SS 3175-FTL Progressive Low Voltage Disconnect Parameter Update

New Cascadia vehicles built between July 1st, 2021 and February 5th, 2025.

M2+ vehicles built between January 9th, 2023 and February 5th, 2025.

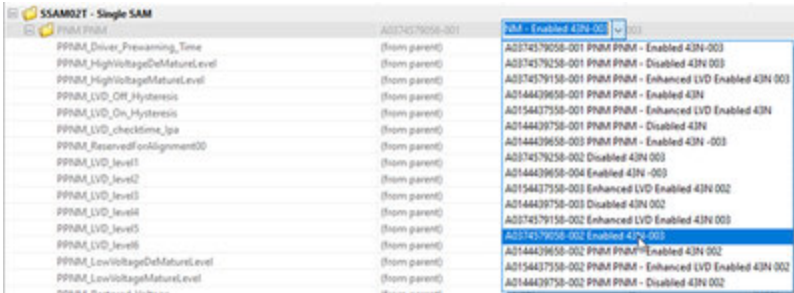
5. Select the part number below in the drop down menu for the PNM group as shown below. **The selection needs to be the next revision of the currently equipped parameter. Please see table below for reference.**

Current	Latest
A0144439658-003, Enabled 43N -003	A0144439658-004, Enabled 43N -003
A0374579058-001, Enabled 43N -003	A0374579058-002, Enabled 43N -003
A0374579158-001, Enhanced LVD Enabled 43N 003	A0374579158-002, Enhanced LVD Enabled 43N 003
A0154437558-002, Enhanced LVD Enabled 43N 002	A0154437558-003, Enhanced LVD Enabled 43N 002

Example: A0374579058-001 Enabled 43N-003 → A0374579058-002 Enabled 43N-003 A0374579058-002 Enabled 43N-003

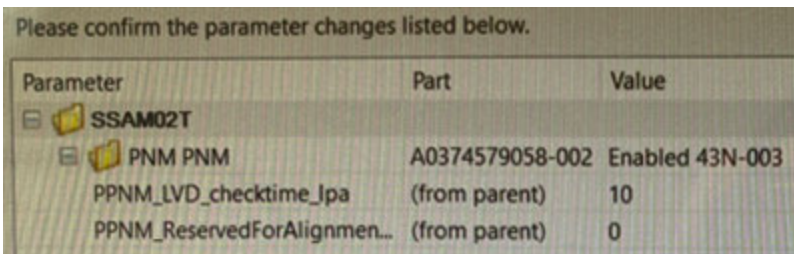
6. Verify the adjusted parameters are showing the correct values. If matching the values below, click **Send**.

Note: These two parameters are the ONLY adjustments.

PPNM_LVD_checktime_lpa = 10

PPNM_ReservedForAlignment00 = 0
